**ADDENDUM NO. 2**

DATE: September 28, 2020  
RE: 1921A1 | Crystal City, Texas – Main Post Office

FROM: Fisher Heck, Inc., Architects  
915 South St. Mary's Street  
San Antonio, Texas 78205  
(210) 299-1500

SHEET NO:  
**S202**

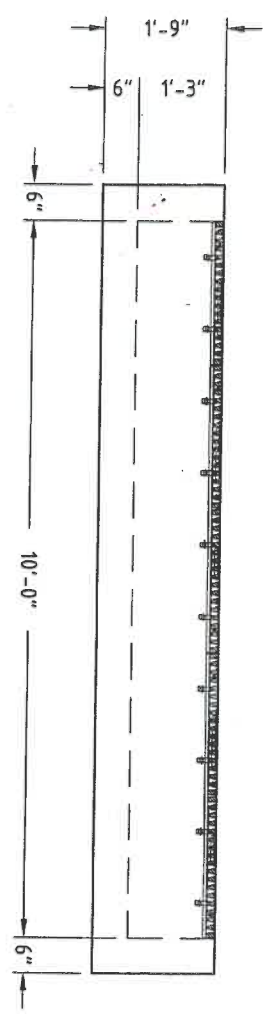
1.07 On Sheet S202 there is a detail section with no call out information. Is this supposed be 4 on S401?

**See revised S202 attached.**

# SLOT DRAIN DETAIL

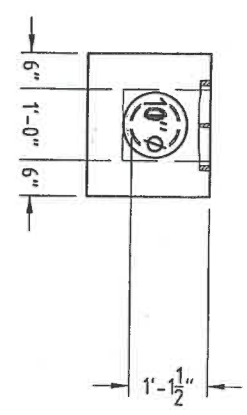
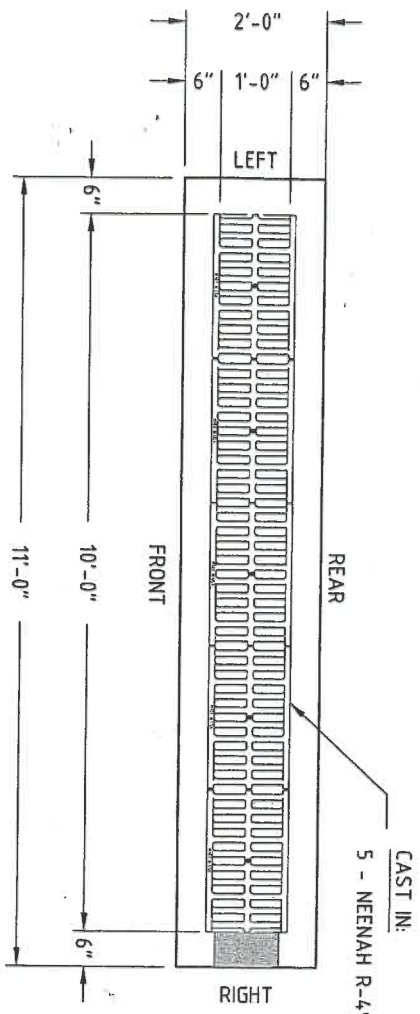
- 1.27 **Civil slot drain detail, see attached.**
